UNITED STATES
DEPARTMENT OF THE INTERIOR
BUREAU OF LAND MANAGEMENT

FORM APPROVED
OMB NO. 1004-0135
Expires: July 31, 2010**SUNDRY NOTICES AND REPORTS ON WELLS**
Do not use this form for proposals to drill or to re-enter an abandoned well. Use form 3160-3 (APD) for such proposals.

CIMAREX ENERGY RESPECTFULLY REQUEST APPROVAL FOR CHANGES TO THE ORIGINAL APD AS FOLLOWS:

Exhibit E-1 – 2000# BOP
Riverbend 14 Federal 2H
Cimarex Energy Co. of Colorado
14-25S-28E
SHL 75 FNL & 1980 FWL
BHL 660 FSL & 1980 FWL
Eddy County, NM

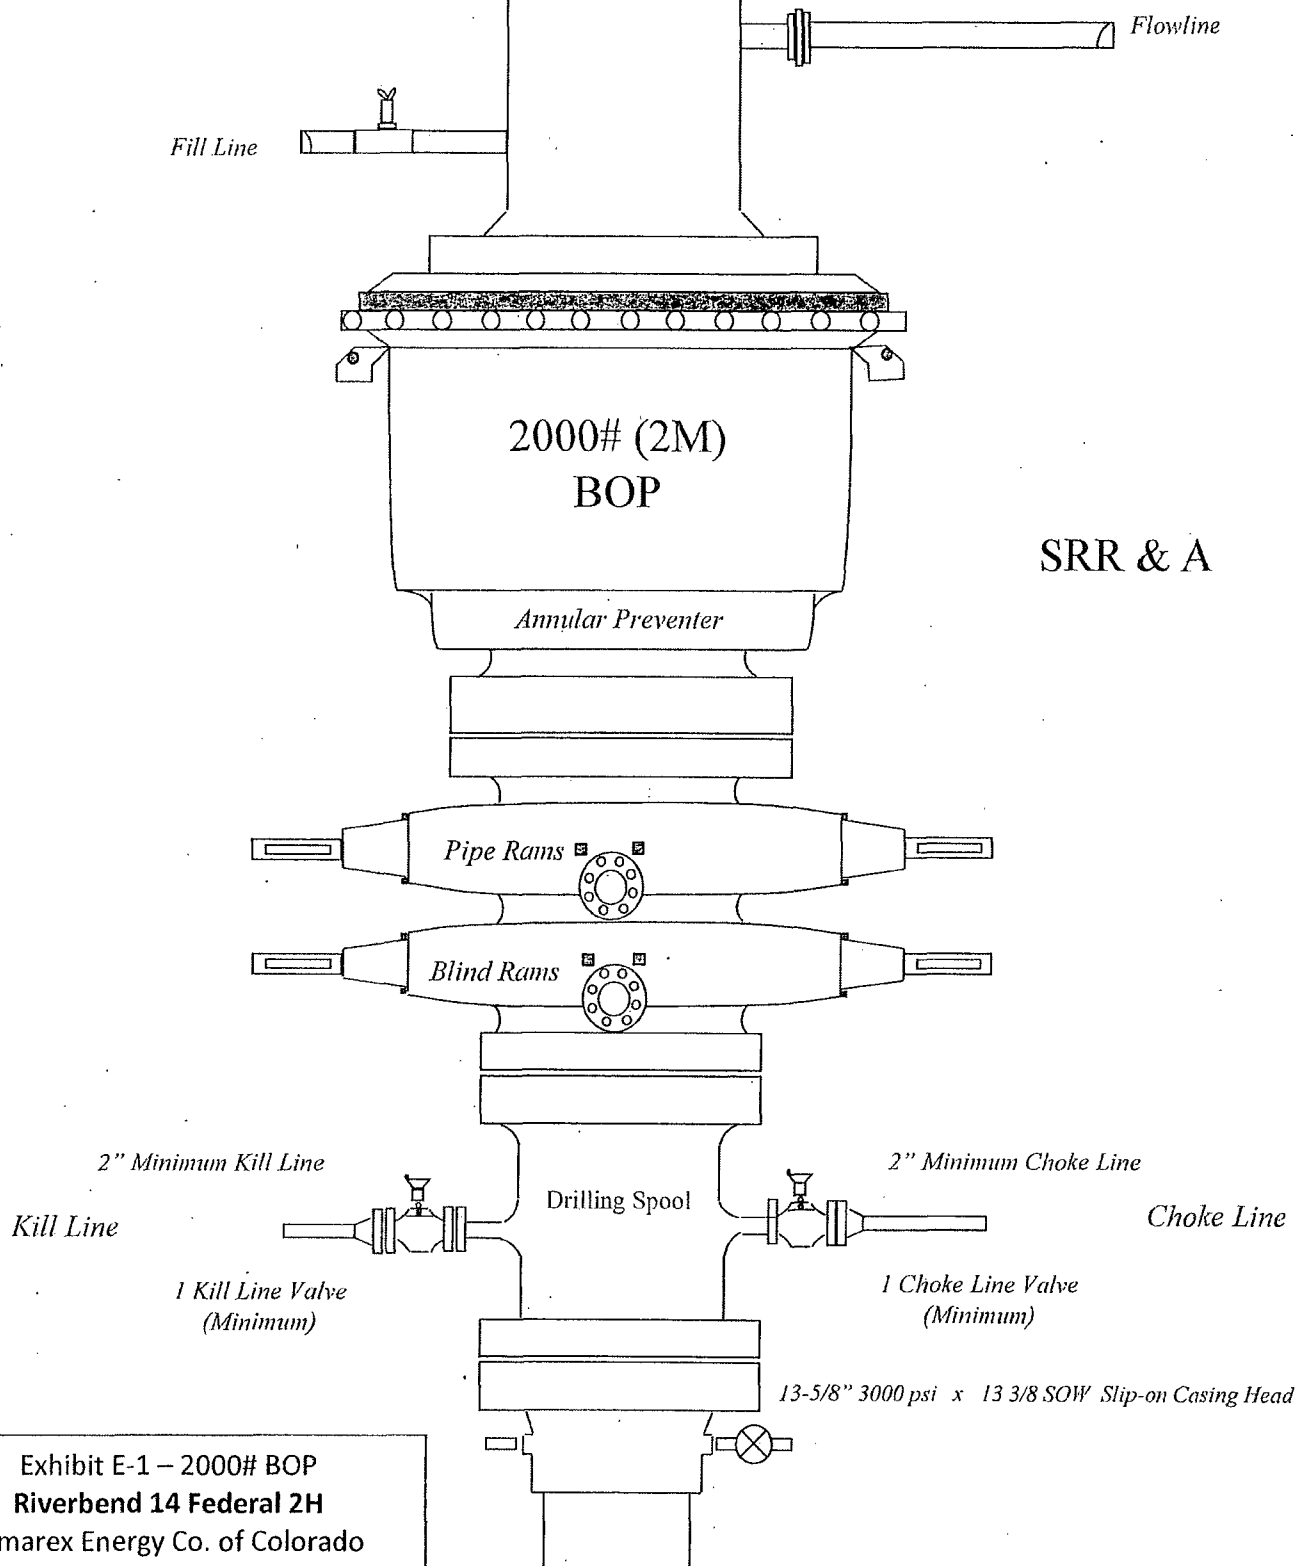
6. Request in the pressure control equipment.

a. Approved: 3M system below surface and 5M system below intermediate.

b. Proposed: 2M system below surface, 3M system below intermediate and 5M system below 7" Intermediate.

Drilling 12-1/4" hole
below 13 3/8" Casing
